CONSTRUCTION PLANS FOR LORSON RANCH EAST

EAST JIMMY CAMP INTERCEPTOR SANITARY SEWER CONSTRUCTION PLANS

Markup Summary

SHEET NUMBER **C8.4**

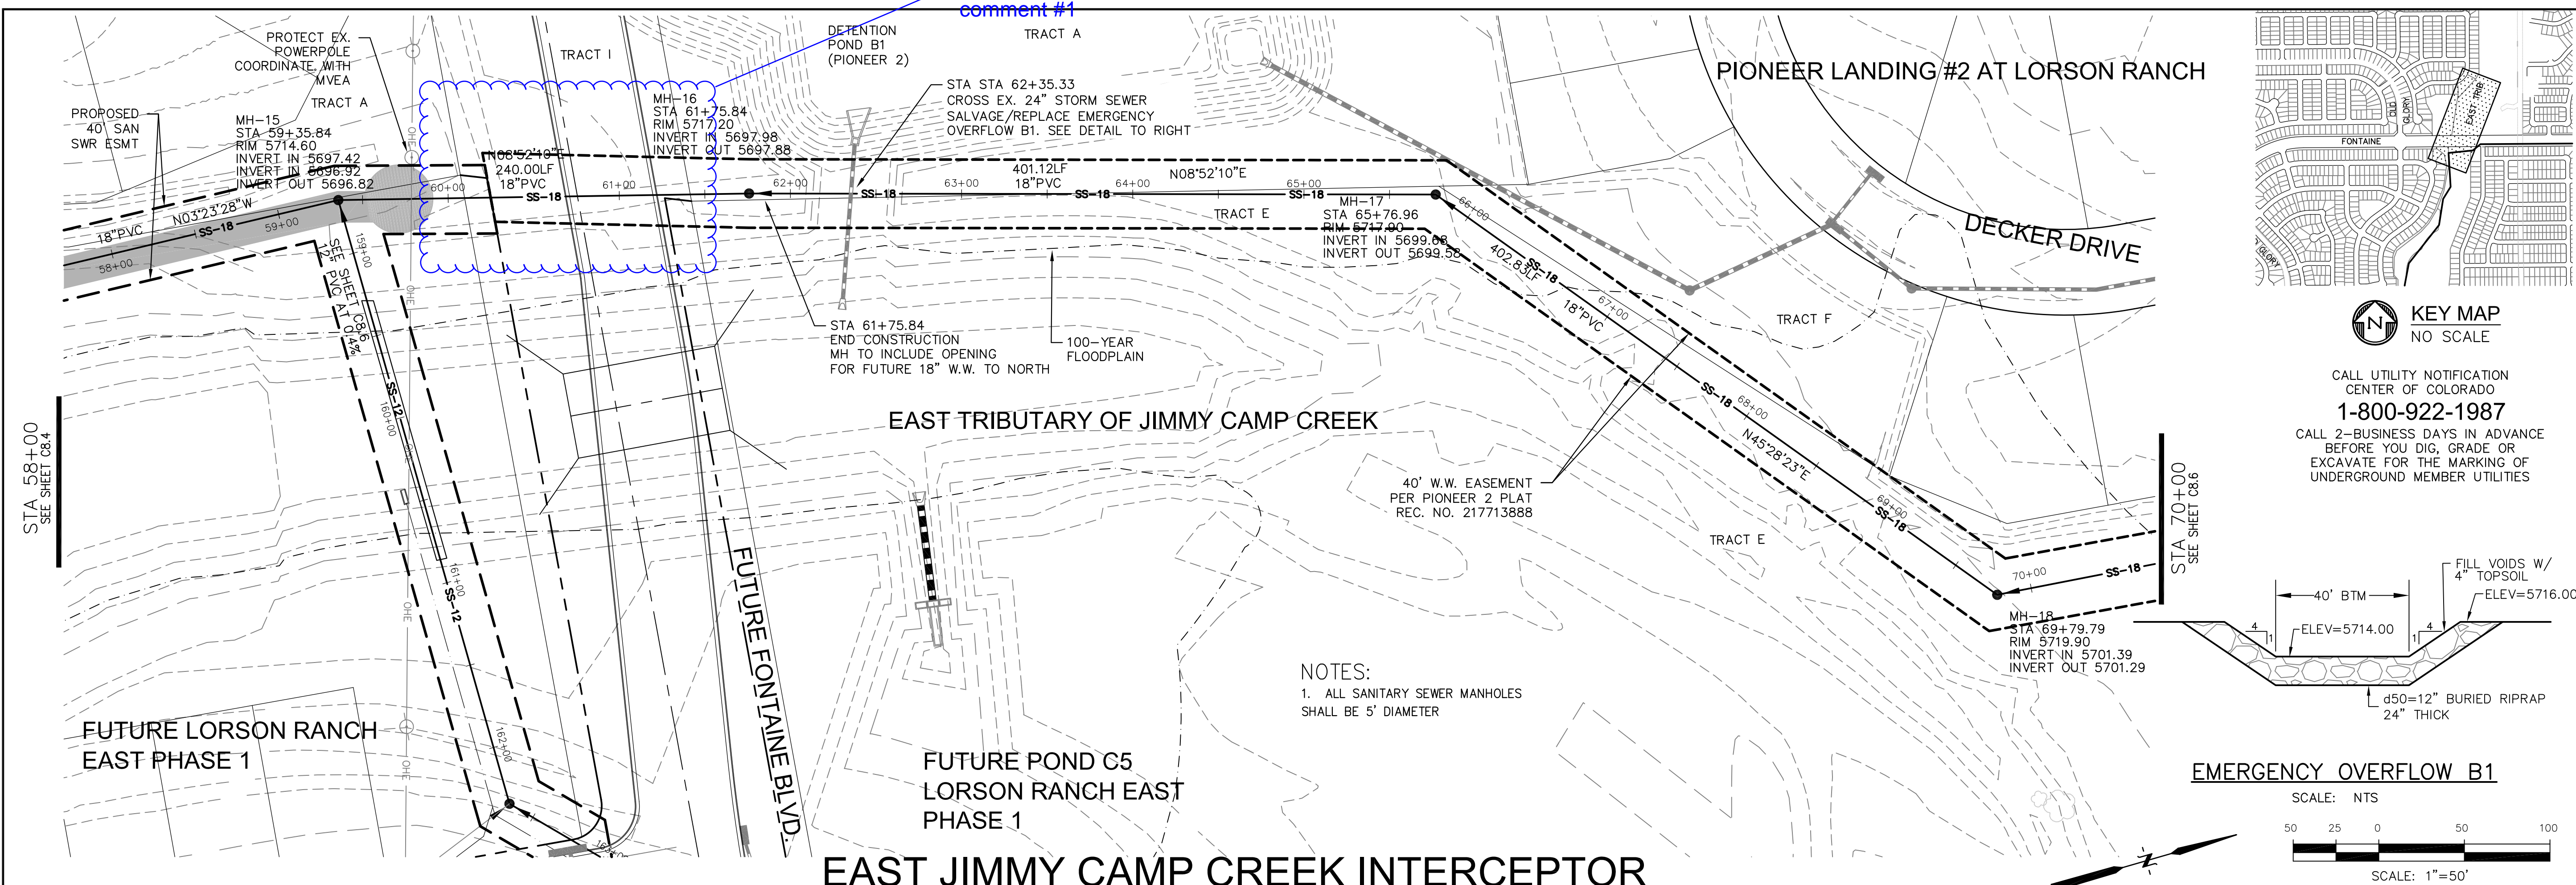
See General comment #1
